- **Applicant:** Robert Roderiques;
- **Agents:** Schneider, Davignon, & Leone, Inc. (Engineers); John Mathieu (Attorney)
- **Owner(s):** Jimmy A. Papas and Nickolas L. Papas
- **Project Location:** Map 28C, Lots 71 and 71A. The proposal is to create frontage for the lots by creating new roads off of Hiller Avenue and Timothy Street. (15-acres total).
- **Proposal:** The current revised proposal is to create fifteen (15) buildable lots with two drainage parcels on Map 28C, Lots 71 and 71A. A proposal to create 16 lots was denied unanimously on January 14, 2020. (Based on Plans received December 6, 2019 and the third Peer Review received December 30, 2019)

Definitive Subdivision: Hiller & Timothy St. Subdivision

DS 2019-01: Remand Review

2018 Preliminary Plan and 2022 Remand Plan Superimposed

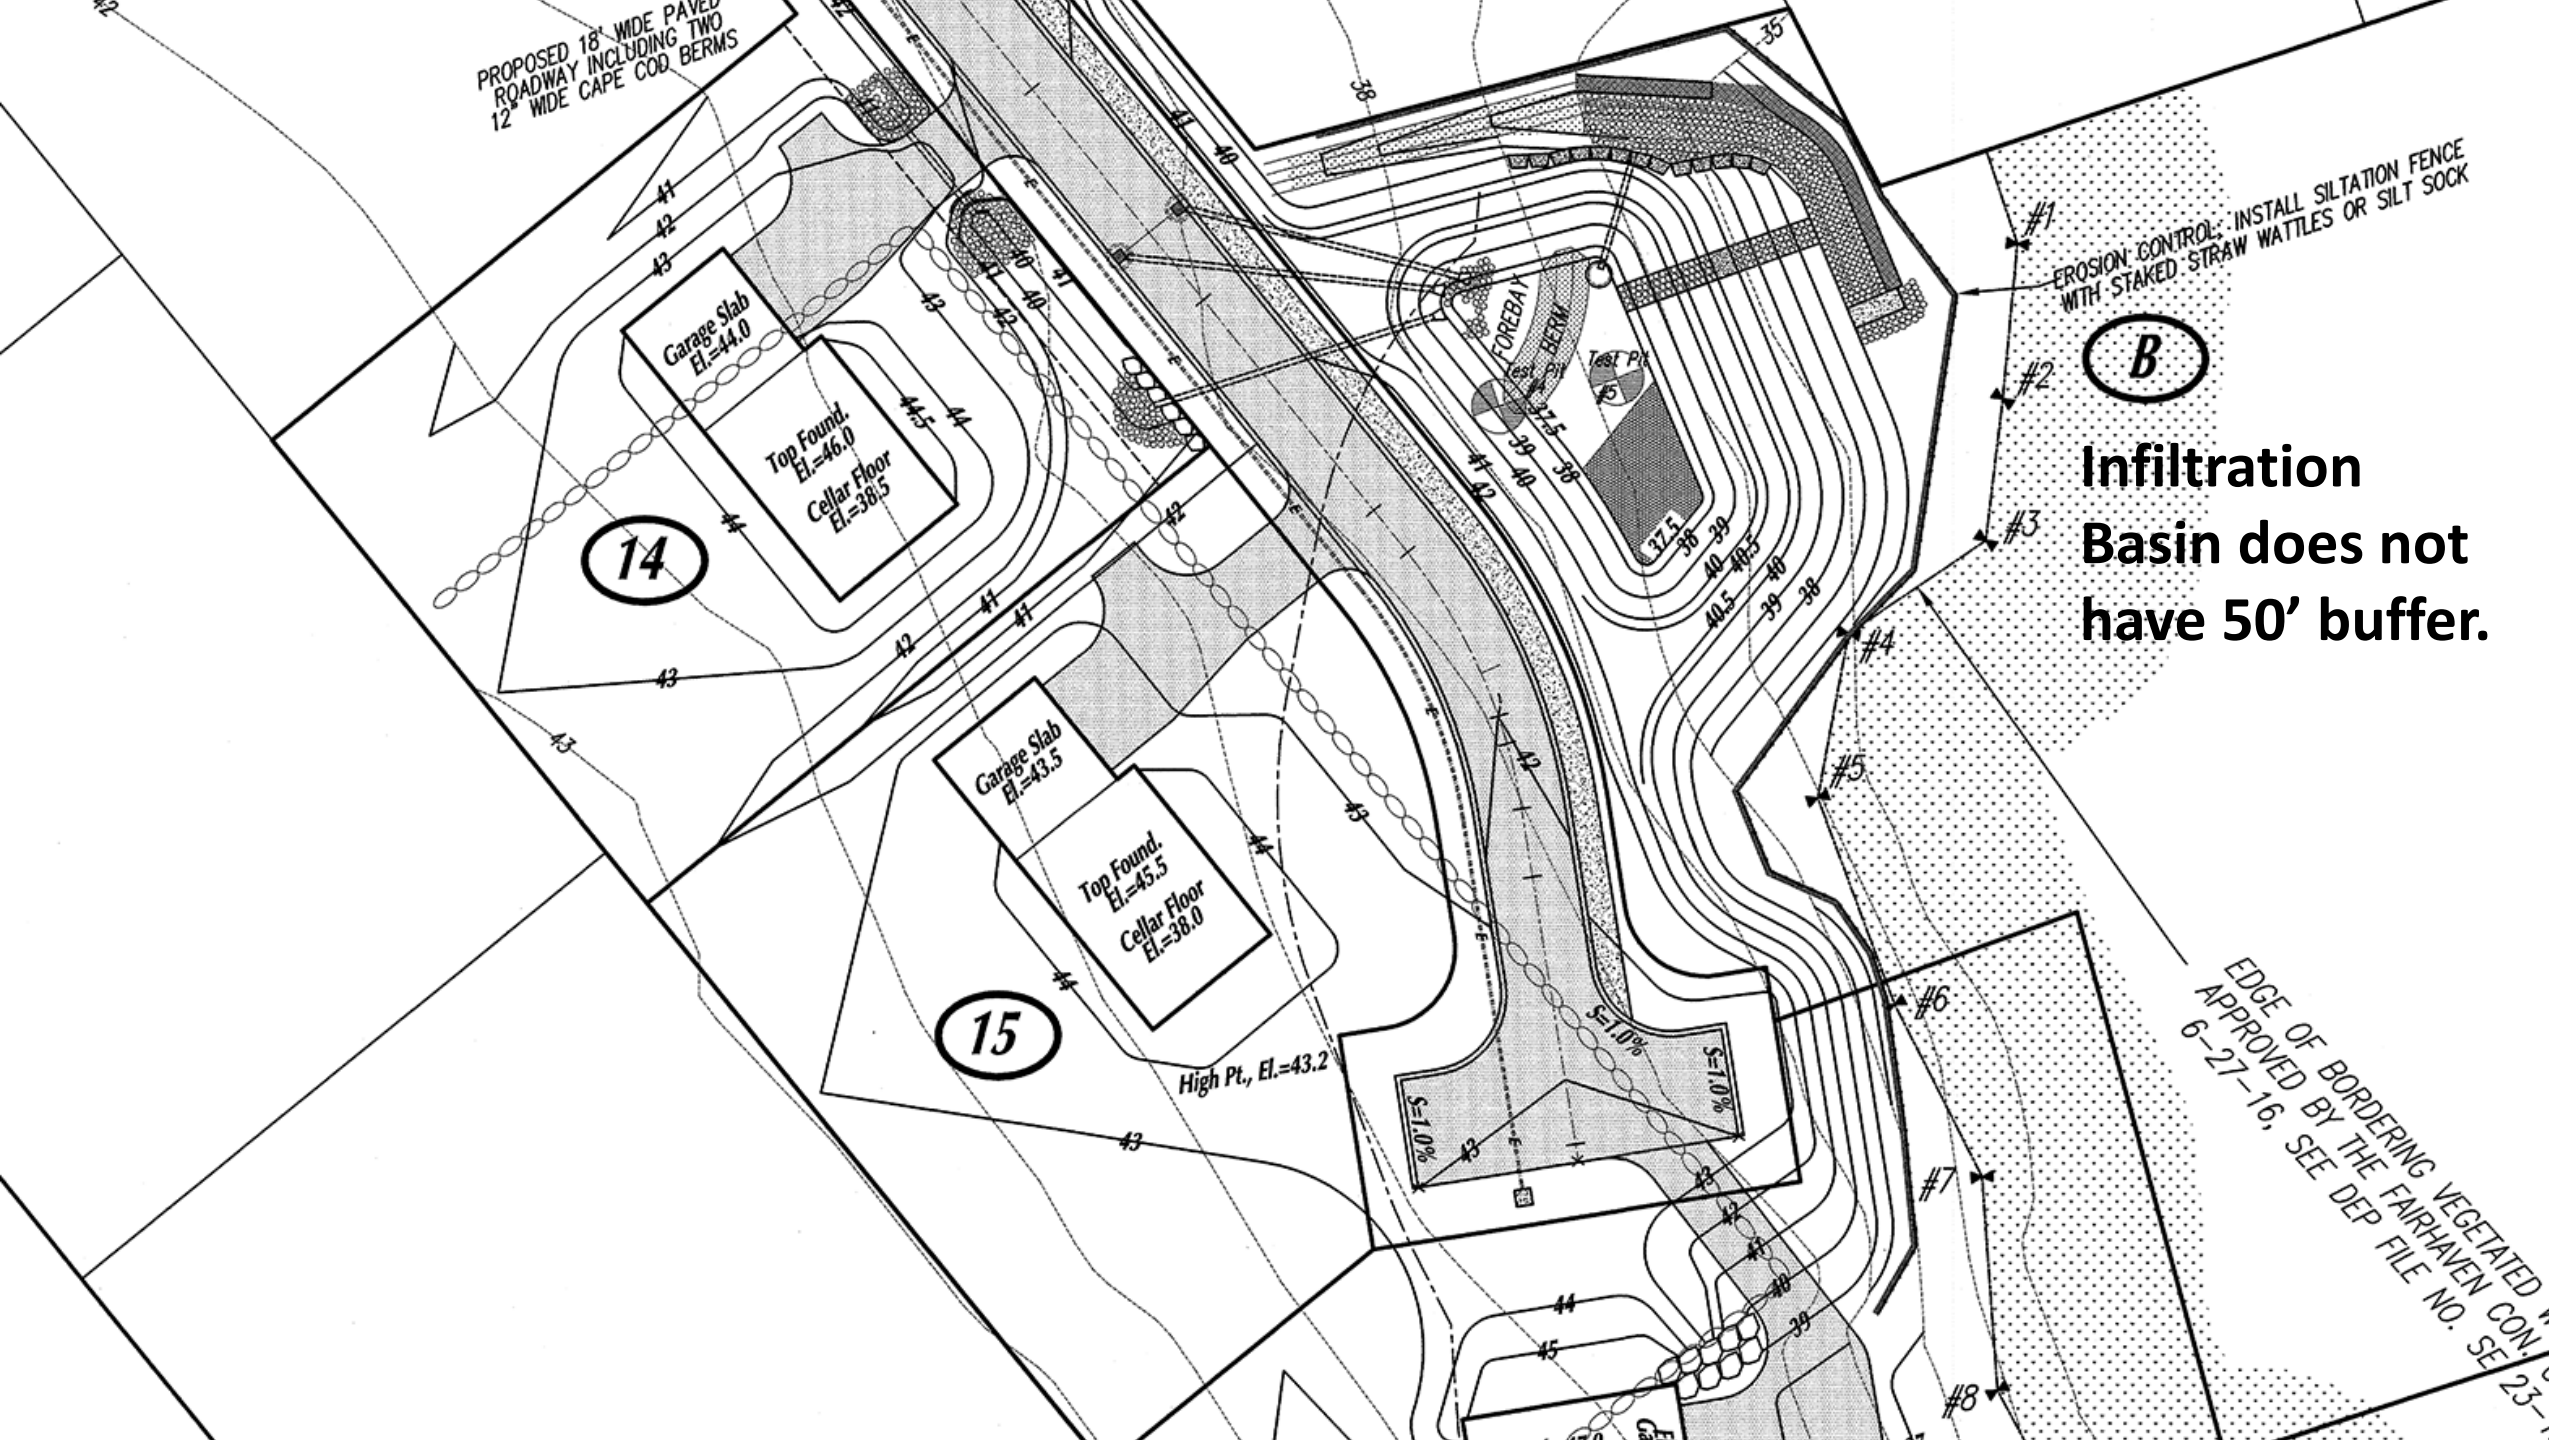
Infiltration
Basin does not
have 50' buffer.
